## Development Services Staff Report

| <b>File Number</b>              | PL2023-319  |
| <b>File Name</b>                | PRELIMINARY DEVELOPMENT PLAN – Outlaw Harley Davidson |

Figure 2 – Parking lot encroachment adjacent to NE Strother Rd.

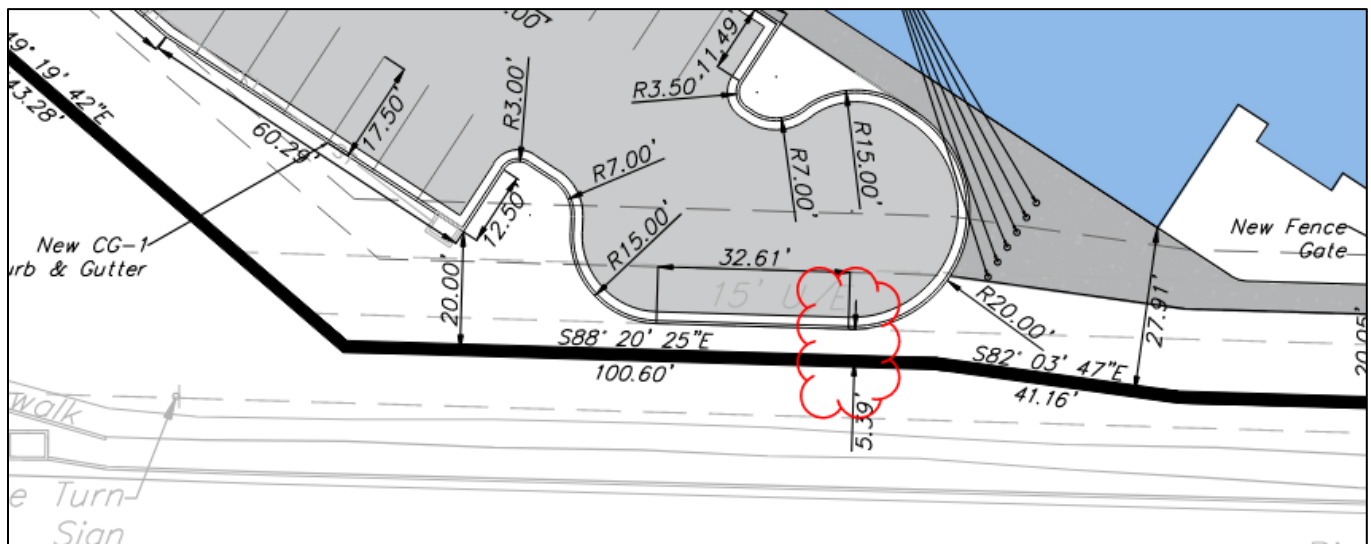
1. The applicant has requested a modification to UDO Sec. 8.620 – Parking lot design.
  - **Required** – 20' minimum setback from public right-of-way.
  - **Proposed** – 5.39' setback from the NE Strother Rd. right-of-way.
  - **Recommended** – The proposed encroachment in to the parking lot setback is to allow for a better turn around access for emergency services. The setback is adjacent to the NE Strother Road Right of Way and in this specific location the right of way is 21.50 feet from the back of curb, where typical right of way is 11 or 12 feet behind the curb. This modification will not create an adverse effect on safety and will provide better emergency services access to the site. For these reasons staff supports the requested modification.

1. A modification shall be granted to the minimum 20' parking lot setback from right-of-way, to allow a 5.39' parking lot setback from the NE Strother Rd. right-of-way.

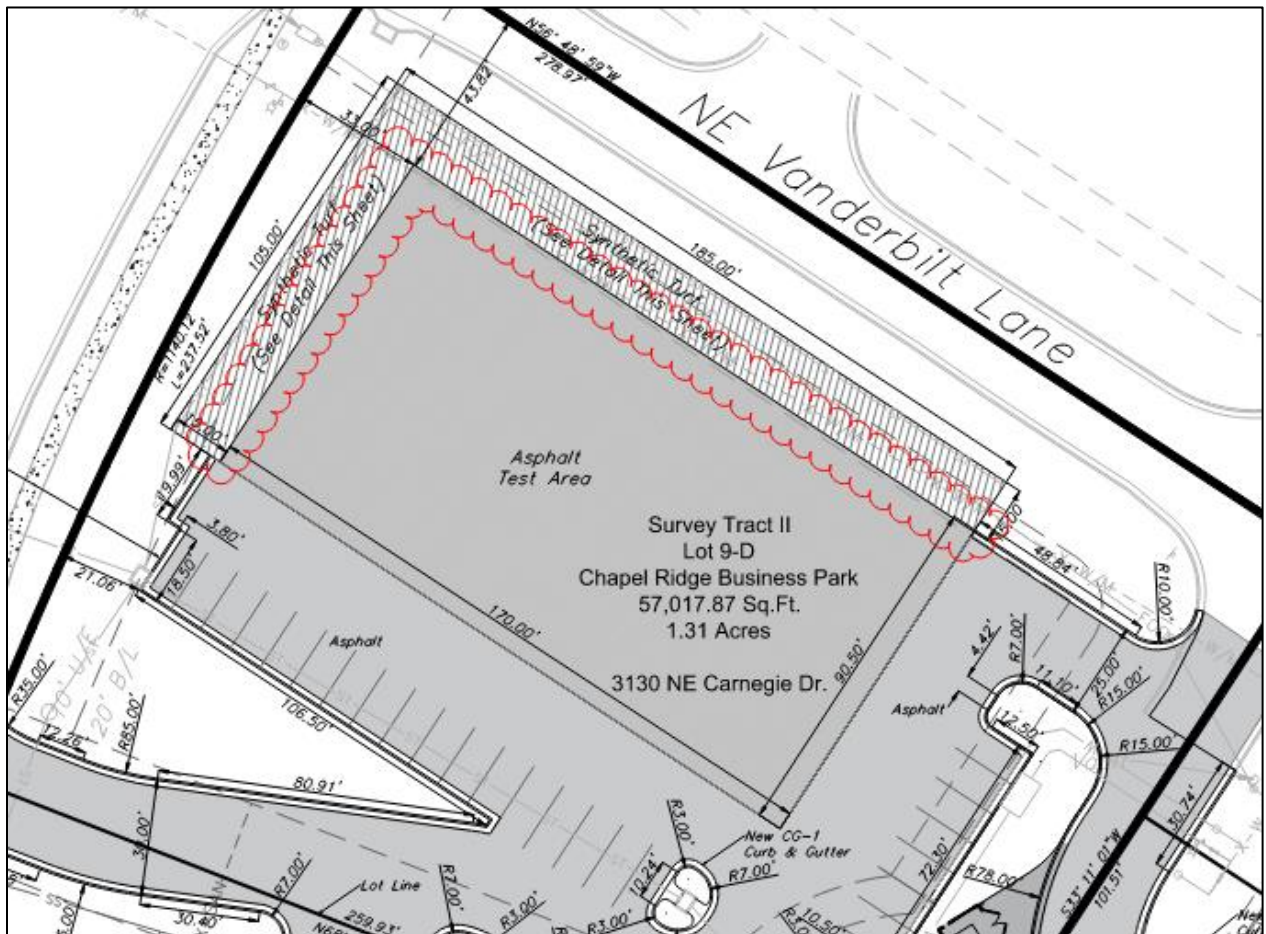
- **Required** – All vehicle parking lot areas and access drives in all zoning districts shall have a boundary constructed of straight-back Portland cement concrete curbing (CG-1) or an integral Portland cement concrete sidewalk and curb with a vertical face.

- **Proposed** – The applicant has proposed to eliminate the curbing along the perimeter of the training area adjacent to NE Vanderbilt Ln and NE Ralph Powell Rd. All other parking areas will have CG-1 curbing and shall comply with the UDO.

- **Recommended** – This part of the site will be utilized as a training new motorcycle riders. Should the curbing be installed per UDO requirements around the perimeter, it could pose a risk to wayward riders. The perimeter will be screened with landscaping and the applicant has proposed to install a no rise ribbon curb to hold the pavement in place. Staff finds the requested modification to be reasonable and supports the requested modification.

2. A modification shall be granted to the required straight-back Portland cement concrete curbing (CG-1) to allow for a ribbon curb type as depicted on the preliminary development plan dated November 17, 2023 & revised December 22, 2023.
